**FINAL DRAINAGE REPORT  
FOR  
LOT 5 OF CLEARWAY  
EL PASO COUNTY, COLORADO**

June 2023

PCD Project No. PPR-22-034

CLEARWAY, LOT 5 (WIRENUT)  
EL PASO COUNTY, STATE OF COLORADO  
PROPOSED DRAINAGE MAP

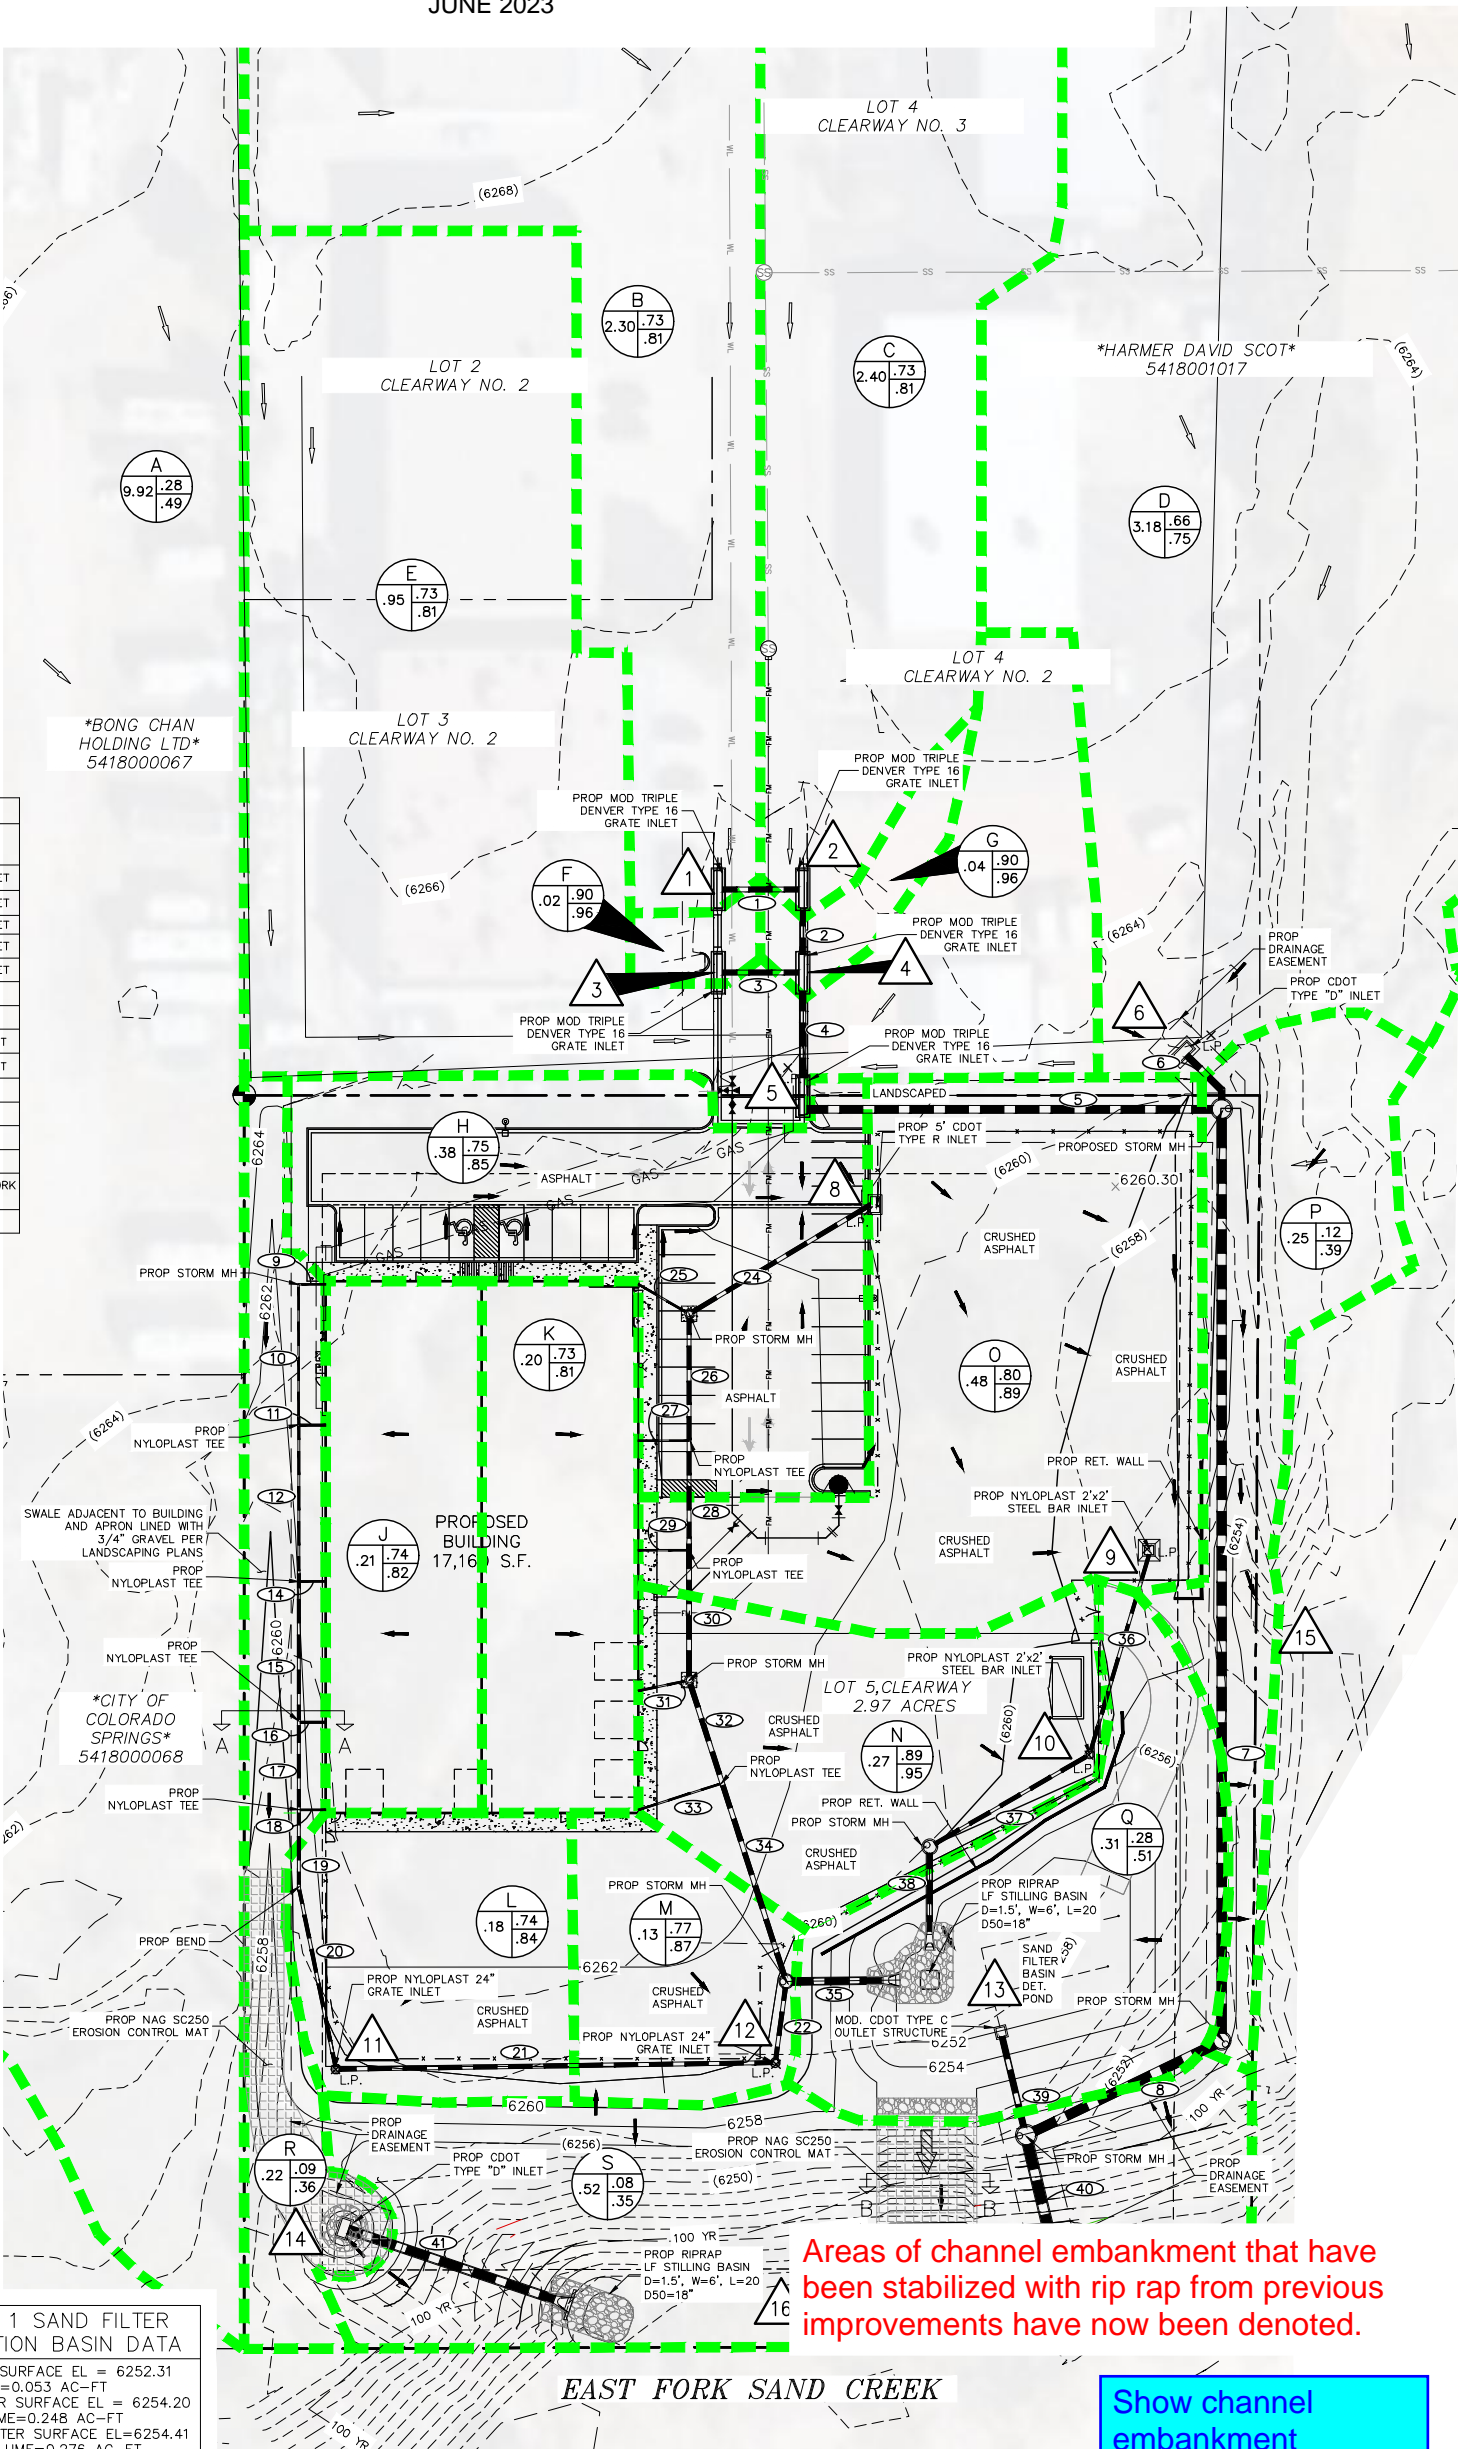
Show channel embankment stabilization area
